**INTERNATIONAL CODE COUNCIL (ICC)
Code Technology Committee (CTC)**

**FINAL REPORT OF THE CTC
AREA OF STUDY – CLIMBABLE GUARDS**

**May 21, 2008
Four Points Sheraton BWI Airport
Baltimore, Maryland**

The following is code change E85 – 07/08 submitted in the 2007/2008 Code Development Cycle which was approved by the both the IBC- Means of Egress and IRC- Building/Energy code committees.

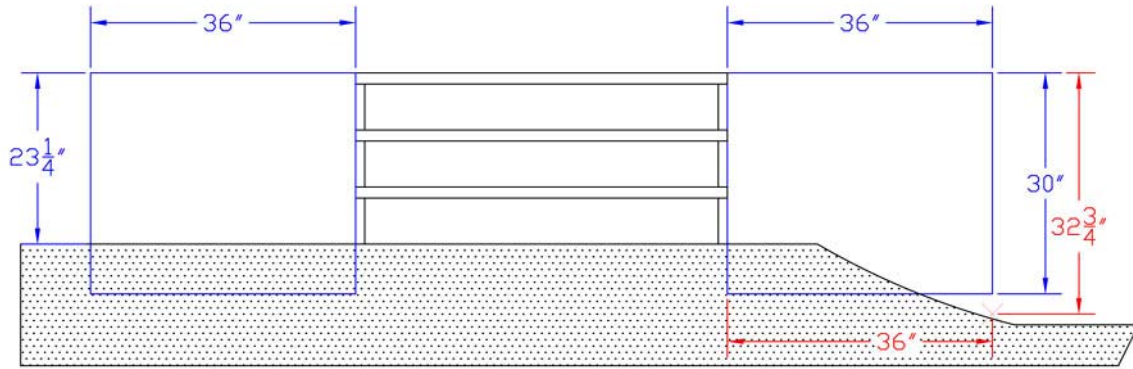
IBC 1013.1. Laundry lists of items in the code are typically not all-inclusive. The word “including” provides this clarification in the following sections as well. This section is divided into two paragraphs with the second paragraph dealing with glass and glazing without a change in intent. The key part of this change to IBC 1013.1 is submitted in order to clarify how the height measurement which triggers the guard requirement is made relative to proximity to the adjacent fall-off. This is illustrated in the following figure:

The view is taken from the landing of a 3 riser stair, looking towards the face of the risers.

1013.1 (IFC [B] 1013.1) (Supp) Where required. Guards shall be located along open-sided walking surfaces, including mezzanines, equipment platforms, stairways, stairs, ramps and landings, that are located more than 30 inches measured vertically to the floor or grade below at any point within 36 inches (914 mm) horizontally to the edge of the open side above the floor or grade below. Guards shall be adequate in strength and attachment in accordance with Section 1607.7. ~~Where glass is used to provide a guard or as a portion of the guard system, the guard shall also comply with Section 2407. Guards shall also be located along glazed sides of stairways, ramps and landings that are located more than 30 inches (762 mm) above the floor or grade below where the glazing provided does not meet the strength and attachment requirements in Section 1607.7.~~

1013.1.1 (IFC [B] 1013.1.1) Glazing. Where glass is used to provide a guard or as a portion of the guard system, the guard shall also comply with Section 2407. Where the glazing provided does not meet the strength and attachment requirements in Section 1607.7, complying guards shall also be located along glazed sides of open-sided walking surfaces.
